Schedule of Amendments Summary _ rev B

Project No: 19032
 Project: **Building A & B Chapel Street Precinct, Rockdale**
 Date: 10.03.2020

10. Lobby & Entry location changed
- Lobbies are connected on ground floor
 - More generous lobbies have been provided with greater amenity for residents
 - Less lobby entrances
 - L1: Building A -Chapel avenue lobby double heights

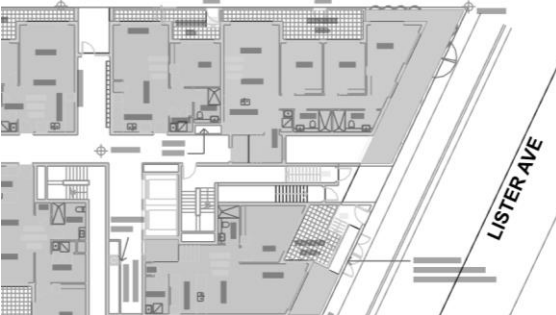
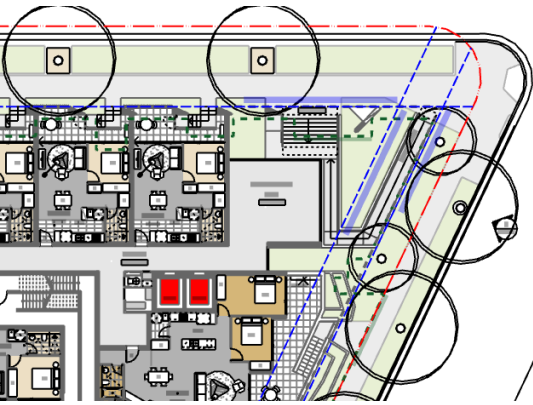
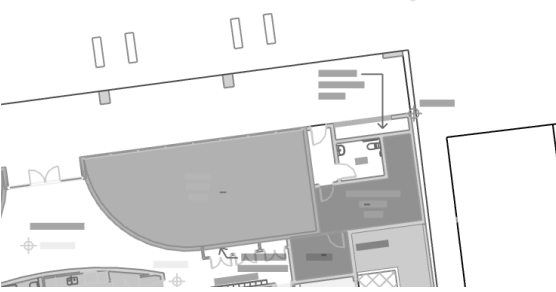
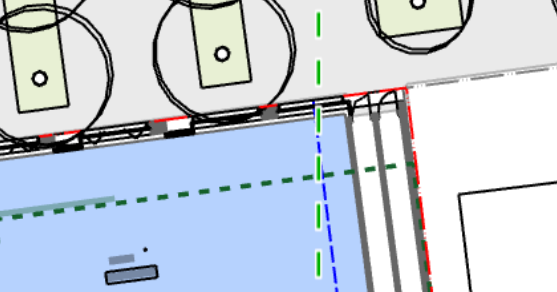
Single lobby entry from both streets proposed

16. Increased setback to the corner of Chapel Lane & Lister Ave. The approved development incorporated the following setbacks:

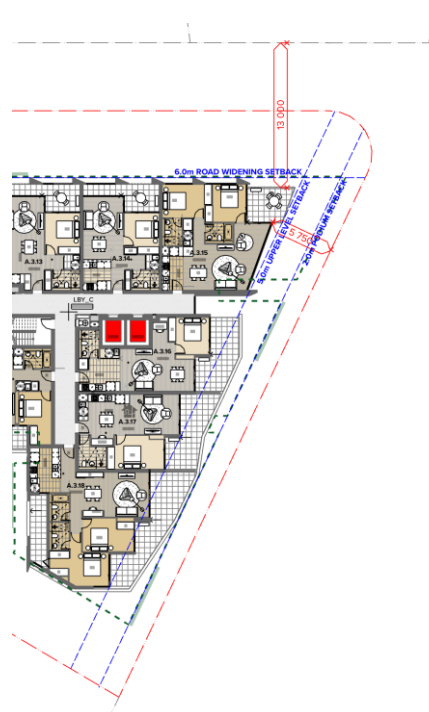
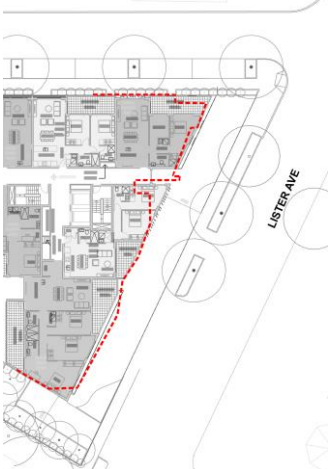
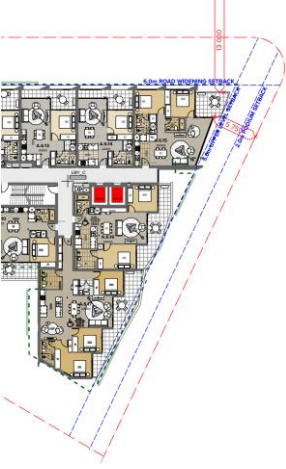
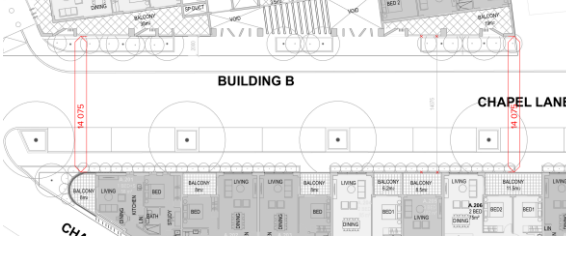
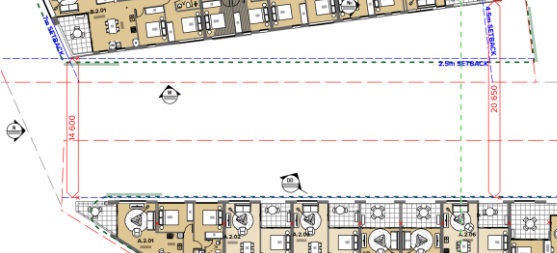
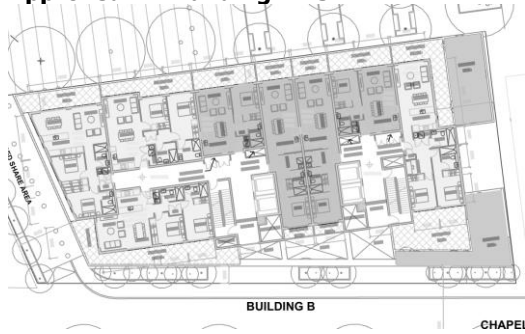
- 12 metres from Chapel Lane
- 2 metres from Lister Avenue podium levels
- 5 metres from Lister Avenue Upper levels.

The amendments proposed to increase these setbacks from between 5.5 to 12 metres (from south to north).

Proposed Communal open space has been increased to meet ADG requirements

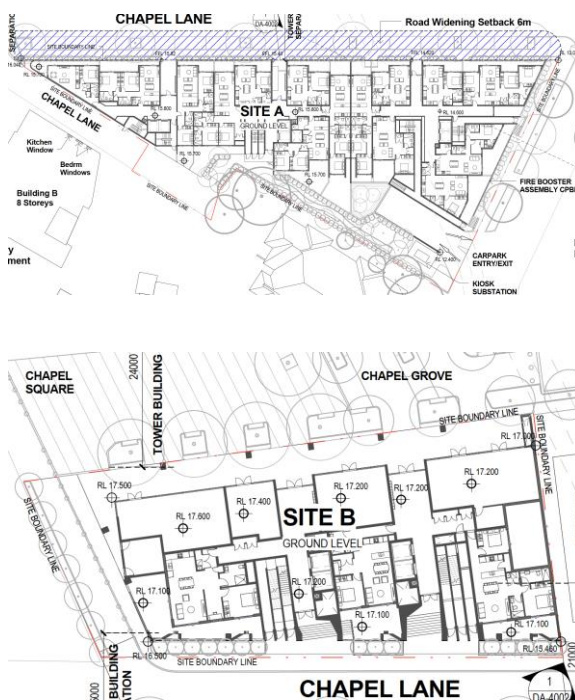
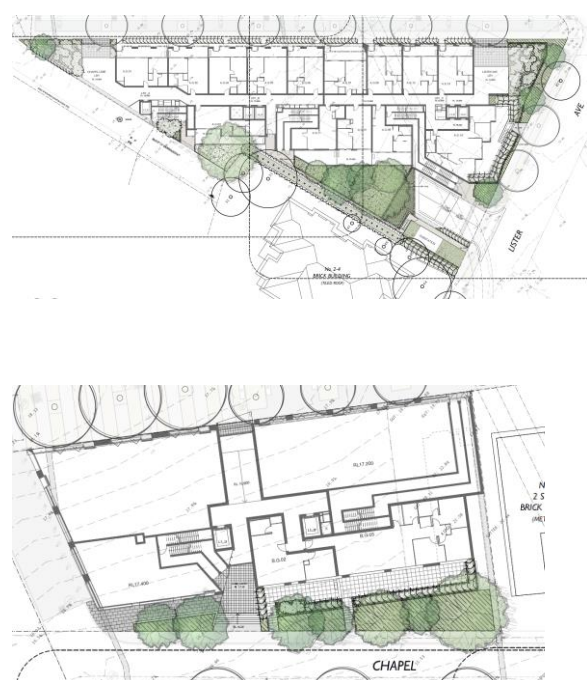
1,180 m²
(24% of site area)

1,227 m²
(25% of site area)
